PLAT TO ACCOMPANY PETITIONS FOR SPECIAL EXCEPTION & ZONING VARIANCES

2401 YORK ROAD
CASE # 94-272-XA

IN THE MATTER OF THE
PETITION OF
JOHN H. SNYDER, NENA T. SNYDER, AND
CHAPEL HOMES, INC.
FOR A SPECIAL EXCEPTION AND
VARIANCES ON PROPERTY LOCATED
ON THE EAST SIDE OF YORK ROAD
NORTH SIDE MAIN BOULEVARD
2401 YORK ROAD
8TH ELECTION DISTRICT
4TH COUNCILMANIC DISTRICT
* * * * *

* BEFORE THE
* COUNTY BOARD
* OF APPEALS
* OF
* BALTIMORE COUNTY
* Case No.: 94-272-XA
* * * * *

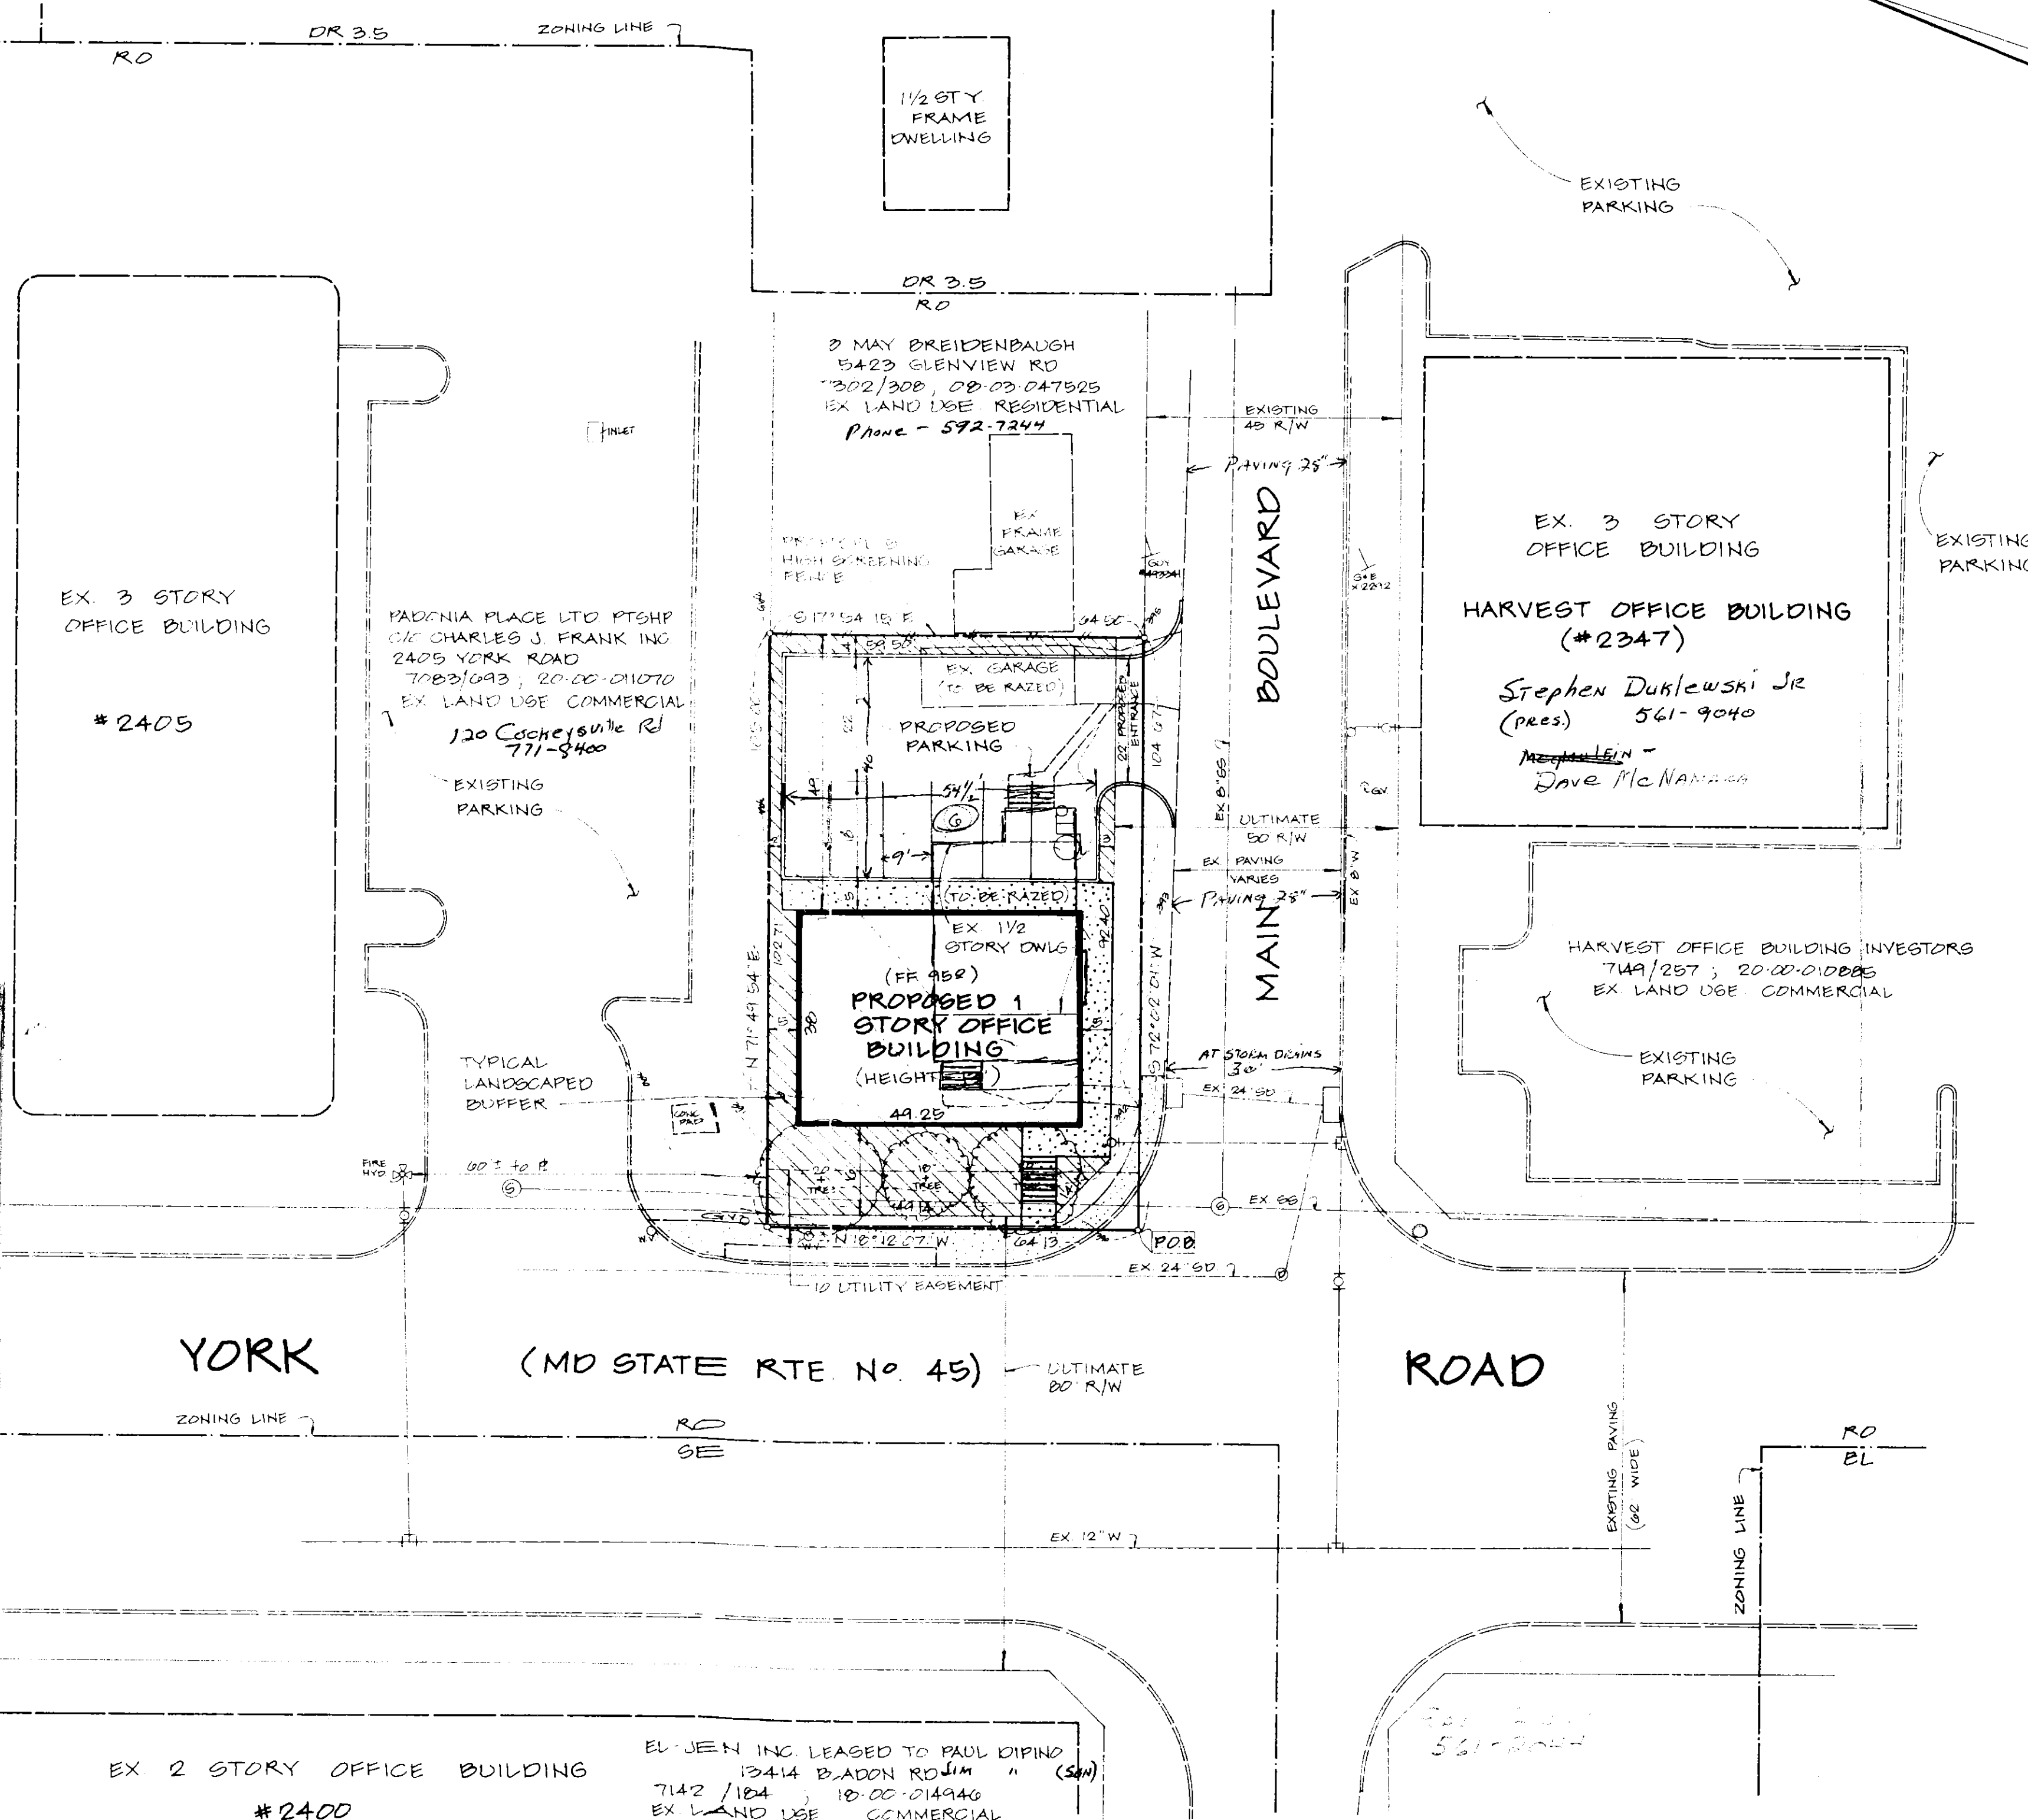
I have talked with ~~the~~ the residents on Main Blvd & to the owners of existing business who will be affected. The sentiments are unanimous that this proposal is much too large for this size lot & will make an already bad situation worse. ~~TURN PAGE~~

Main Blvd. is a dead end street. It does not even have a turn around circle at the end. The road paving is 28' across. People are already parking on both sides, which only leaves 12' or 14' max for traffic depending how they park. There is no other way in or out. Traffic turning in off York Rd. cannot safely pass another vehicle coming out. Cars are often parked half way up Main Blvd. Someone has to back up. This goes on now all day.

Chapel Homes is only providing a space 40' x 55' with proposed parking for 6 cars. I am told that there will be at least 4 people employed there. Assuming each as a car, that leaves two spaces for the customers, architects subcontractors, salesmen, engineers & whoever else does business with Chapel Homes. There is no way the traffic generated by this business can be contained within the limits of the property.

These ^{NINE} Requests for variations to the existing
Zoning regulations, if granted, will make a total
mockery of the process & cause additional hardship
& aggravation to the residents of Main Blvd. It
will certainly not help the value of our properties & will
decrease the quality of life another notch.

8TH ELECTION DISTRICT BALTIMORE COUNTY, MD
SCALE: 1"= 20' JANUARY 3, 1994
REVISED JULY 25, 1994

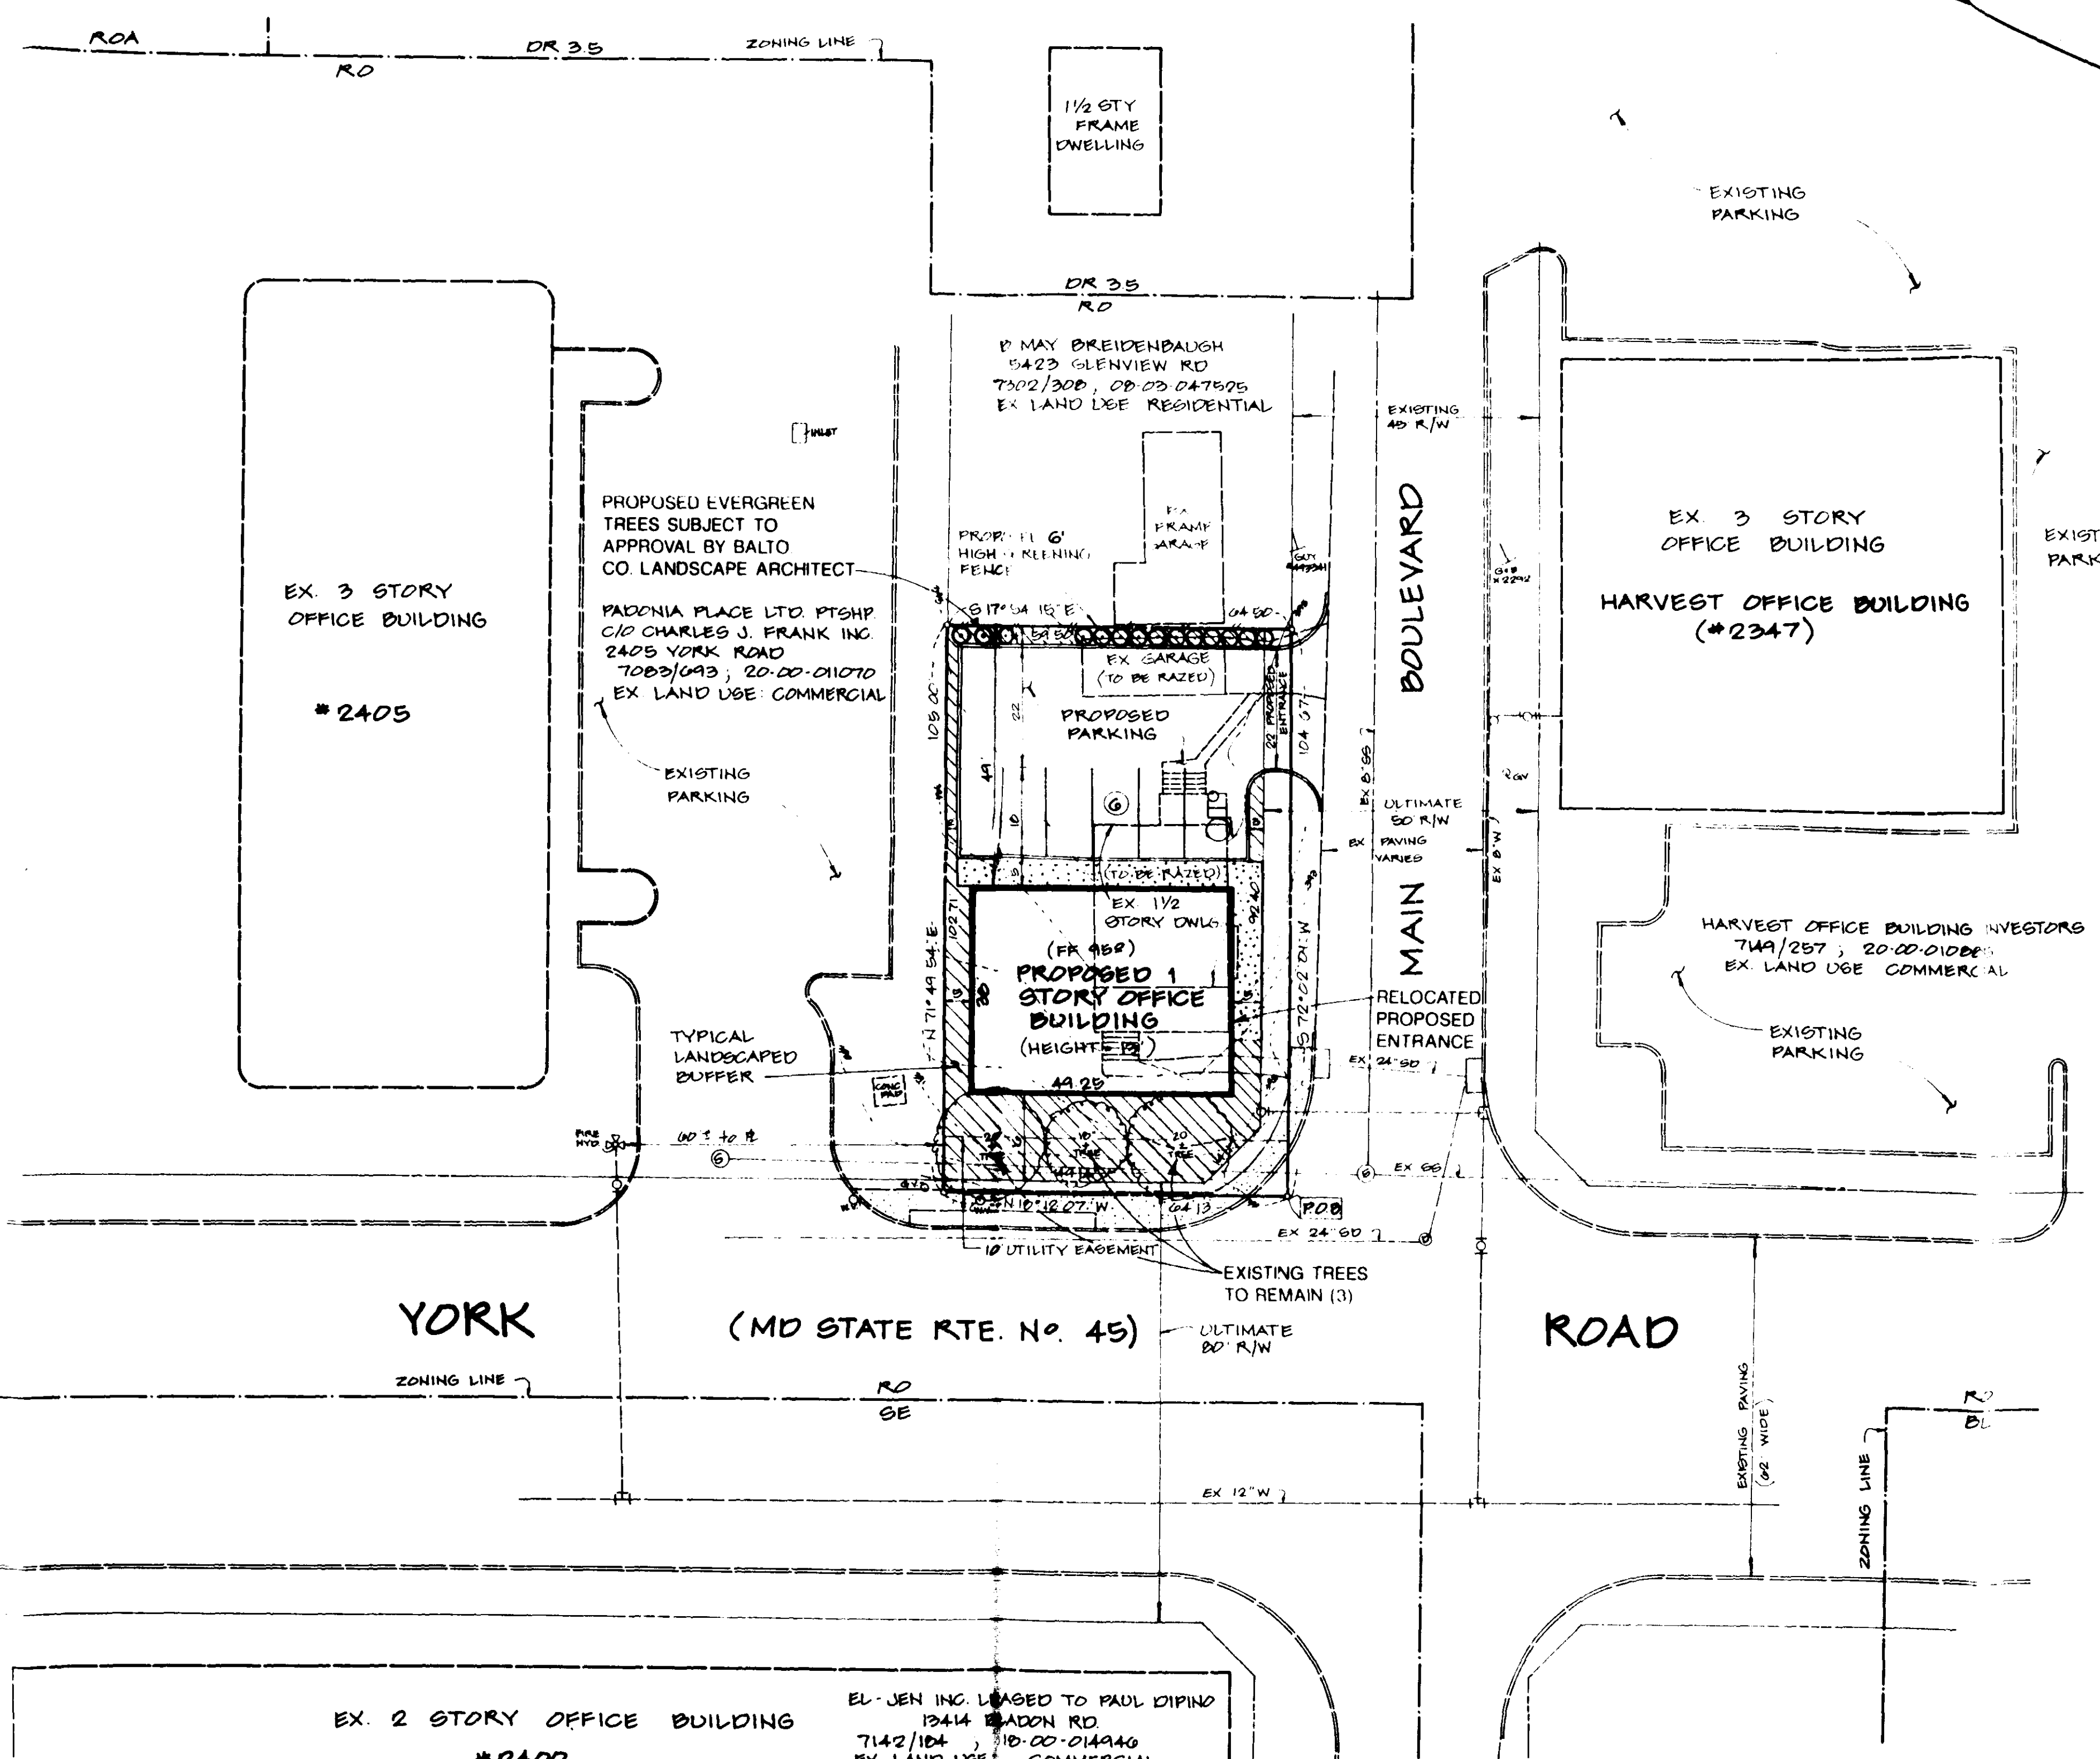
The existing site is located between two Class B office buildings and the proposed use is appropriate.

The site is very small however. Reductions in building and parking setbacks should be compensated for by an increase in landscape buffering. The screen fence along the rear should be increased in height to 6' and planted with a row of evergreen trees such as Leland Cypress. The three existing 18-20" caliper trees at the front should be preserved by recessing the proposed building entrance and relocating access to the side.

5. The Petitioner shall increase the height of the fence on the rear of the property from 5 ft. to 6 ft. The fence line should further be buffered with a row of evergreen trees such as Leland Cypress.

6. Prior to the issuance of any building permits, the Petitioner shall submit a landscape plan for approval by Baltimore County's Landscape Architect, consistent with the comments and restrictions herein.
